Adriano Pupilli Architects
Attention: Matthew Ryall
PO Box 770
Manly NSW 2095
(sent by email only to mr@adrianopupilli.com.au)

10 January 2020

Coastal Engineering Advice on Long Reef SLSC Redevelopment

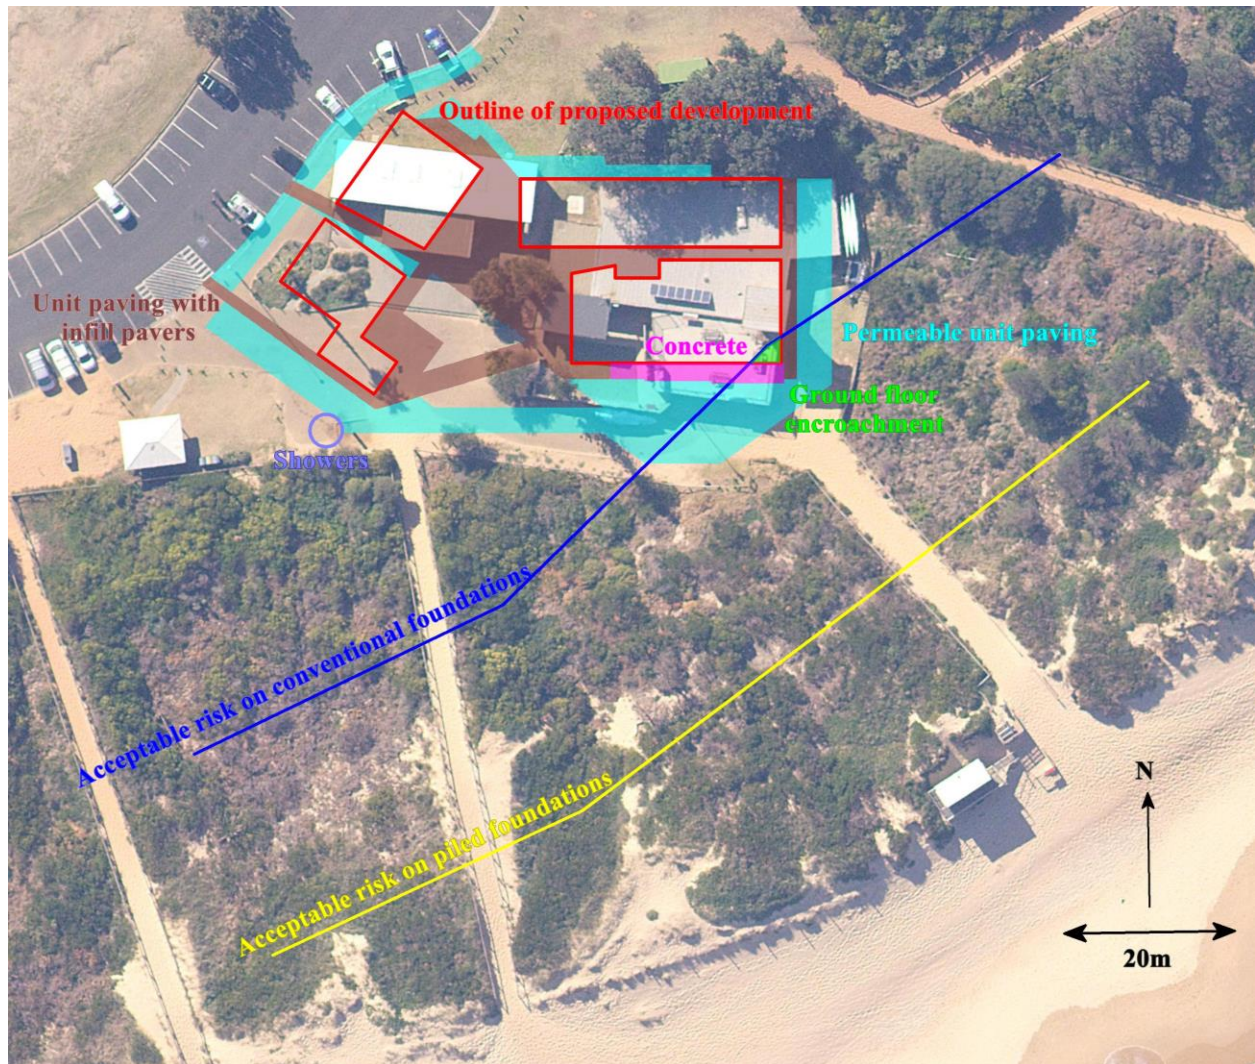
It is evident that the proposed development is generally landward of the “acceptable risk on conventional foundations” line, meaning that it can generally be placed on conventional foundations (from a coastal engineering perspective). That is, foundation design for the proposed development can generally be undertaken with consideration of structural and geotechnical issues only, without coastal engineering input, except as noted below.

A small area of the ground floor extends (encroaches) seaward of the “acceptable risk on conventional foundations” line, as depicted in Figure 3. Based on discussions with Adriano Pupilli Architects and the structural engineers for the development, Partridge, it is understood that it is desired to avoid piling of this ground floor encroachment area. Given that Council has stipulated a literal interpretation of the “acceptable risk on conventional foundations” line, and stipulated that a 100 year planning period was to be adopted for the coastal engineering analysis, to avoid piling it is necessary for the development to be cantilevered over the encroachment area. It is understood that the proposed stiffened raft foundations of the structure will be thickened and more heavily reinforced landward of the “acceptable risk on conventional foundations” line to enable this cantilever. If possible, it is also recommended that the concrete area to the south of the SLSC (magenta in Figure 3) is cantilevered where seaward of the “acceptable risk on conventional foundations” line, in this manner.

At the SE corner of the proposed SLSC building there is to be paving (both permeable units and units with infills) extending seaward of the “acceptable risk on conventional foundations” line. Given the long period (in the order of 100 years) before this area is likely to be impacted by coastal erosion/recession, the pavers are considered to be acceptable from a coastal engineering perspective. If this area is threatened in the future, there may be consideration of removing the pavers so that they are not undermined and end up scattered over the sandy beach area, where it would be difficult to find and recover all paving units.

geotechnical issues only, without coastal engineering input. It is understood that the proposed stiffened raft foundations of the structure will be thickened and more heavily reinforced landward of the “acceptable risk on conventional foundations” line to enable a cantilever seaward of this line at the SE corner of the building. It is recommended that the concrete area to the south of the main SLSC building is also cantilevered in this manner.
